Revision: 1.0

Date: Dec. 19, 2012

PETREL V11 RELEASE NOTES

Figure 2: Center Row Setup Menu and Displayed Result

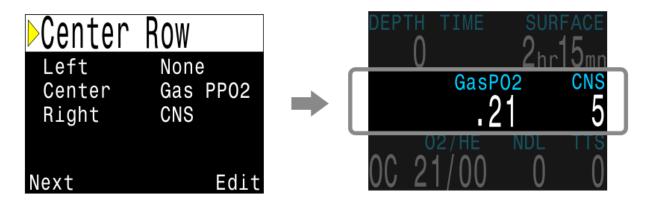
NEW FEATURE – User Configurable Center Row Displays

The values displayed on the left and right side of the center row can now be configured by the user (see Figure 2). Not available when three external PPO2 values are being displayed.

Figure 3: Dive End Time is the time-of-day when the dive ends.

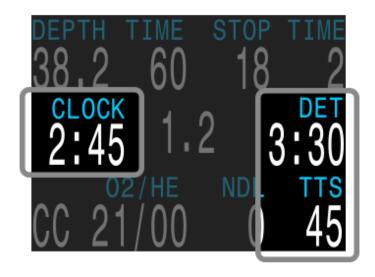
NEW FEATURE – Dive End Time (DET)

The Dive End Time (DET) is the time-of-day when the dive will end.

For example, if the time-of-day is 2:45pm and the TTS is 45 minutes, then the DET is 3:30pm (Figure 3).

The DET is only available in the new left or right configurable center row positions. The DET uses the same format (either 24 hour or am/pm) as the system setting. If in the am/pm format, then it does not show "am" or "pm".

Figure 4: Choose the dives to download (by default all new dives are selected)

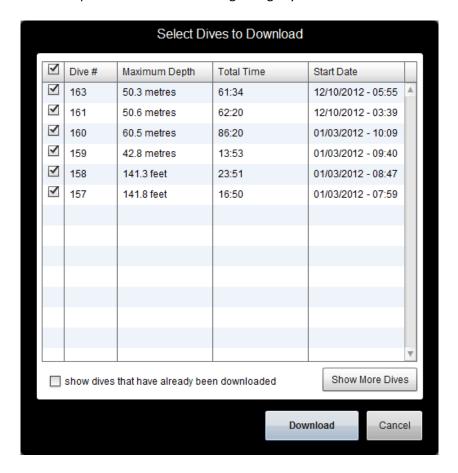
NEW FEATURE – Individual Dive Log Downloads

The dive logs can now be individually downloaded to your desktop or laptop computer.

The Shearwater Desktop user interface has changed slightly.

After connecting to Petrel by Bluetooth, a list of dives will be shown (see Figure 4), most recent dive first. Only new dives are shown, but all dives can optionally be shown. Choose the dives and press the "Download" button to begin.
